FIELD SERVICE BULLETIN

FSB Number:	LVCCFSB2004-190
Author:	Max Dekirmandjian
Date:	September 27, 2004
Total No. of Pages:	3
Subject:	C380 Cracked Rear Housing
Model Affected:	C380
Level of Repair:	1

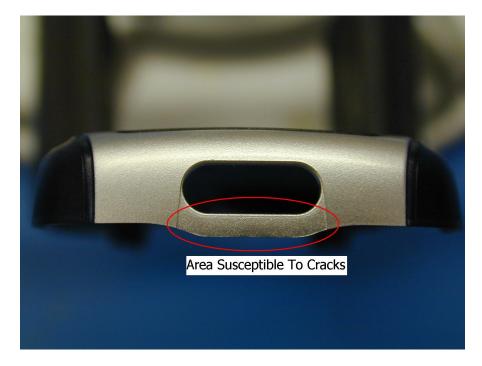
Service has been made aware of an issue with the C380 Rear Housing P/N's CFHN9029A (Blue) or CFHN9036A (Black). It is possible for the plastic housing to crack near the latch when installing or removing the rear housing. The plastic material used on the rear housing can become brittle, thus resulting in cracks. Refer to photo below:

The supplier has modified the housing molding process. The change consists of switching to a smaller barrel in the molding press where the material passes from solid to fluid. In doing this, the time that the material is at a hot temperature is reduced, resulting in less material degradation and improved mechanical performance. These process changes have taken place starting Sept 20, 2004.

On all C380 units returned for service, remove the rear housing and verify the housing's date of manufacture. If the date code is prior to Sept 20, 2004, replace the rear housing with a date code of **Sept 20, 2004 or later**. The photo below shows the location of the rear housing's manufacturing date.
